MONTGOMERY COUNTY HISTORIC PRESERVATION COMMISSION
STAFF REPORT

Address:	14 Hesketh Street, Chevy Chase	Meeting Date:	10/8/2025
Resource:	Contributing Resource Chevy Chase Village Historic District	Report Date:	10/1/2025
Applicant:	Allison Giles (Jennifer Goon, Agent)	Public Notice:	9/18/2025
Review:	HAWP	Tax Credit:	No
Case Number:	1111377	Staff:	Laura DiPasquale
Proposal:	Window replacement

Figure 4: Existing and proposed window elevations (typical). The red lines show the differences in alignment of the top, meeting, and bottom rails.

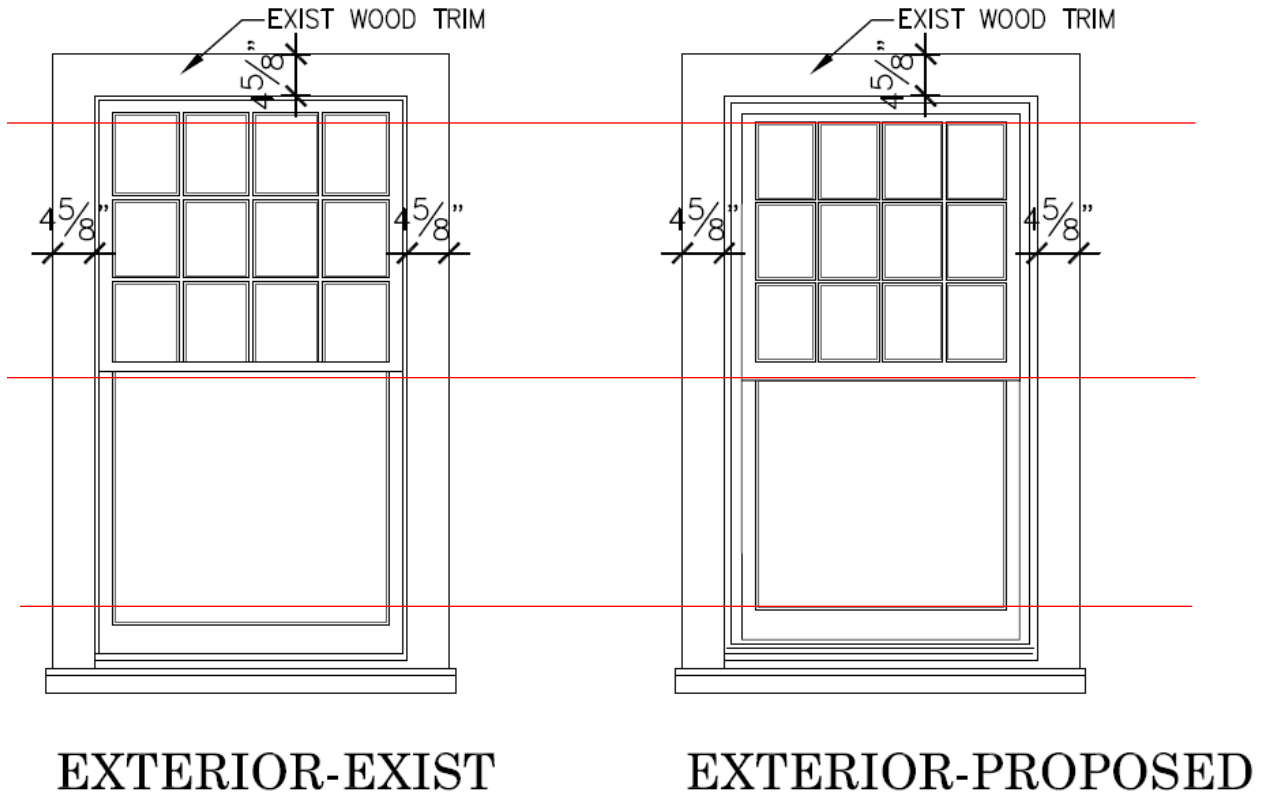
Owing to the subframe, subsill, and screen clip of the proposed windows, the proposed inserts will not sit precisely in the same plane as the existing sash and will reduce the daylight opening of the windows by approximately 1 inch on all sides, with the greatest differences at the side and bottom rails. The bottom of the proposed meeting rail aligns with that of the existing meeting rail, but the proposed meeting rail is slightly taller than the existing. The plane of the proposed sash will shift forward approximately ½ inch so that the front of sash aligns with the existing stop, rather than being set behind it. Staff noted to the

applicants that there is a gap shown between the proposed insert and existing stop molding. The proposed jamb detail appears to show a piece of aluminum capping but the head detail does not. The applicants have confirmed by email that there will be “minimum capping to cover the gaps – we will not do any capping over the exterior trim.”

W16, W17,
W18, W19

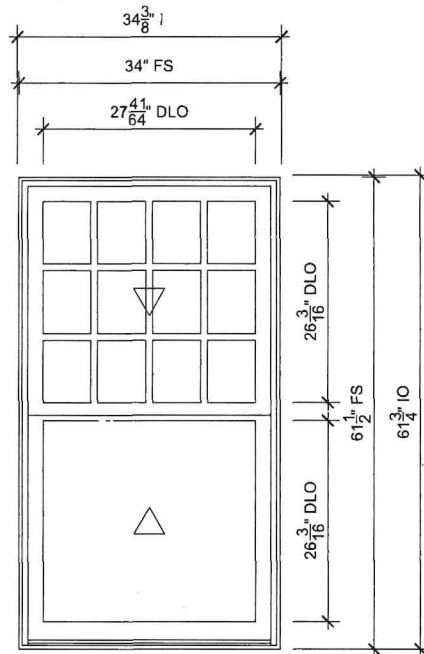
windows. Staff notes, however, that the window specifications only key to 6 front windows as being replaced with Marvin Ultimate (W1, 2, 3, 7, 8, and 9), while W16, 17, 20, 21, 23, 26, 27, and 28 are shown as Elevate. Staff recommends that the applicants submit revised materials correctly identifying the locations and proposed window lines so that there is consistency in the replacement across each given elevation.

1. The applicants must submit revised specifications and/or keyed elevation photographs correctly identifying the line of windows to be used, which should be consistent across a given elevation prior to final approval of the HAWP.
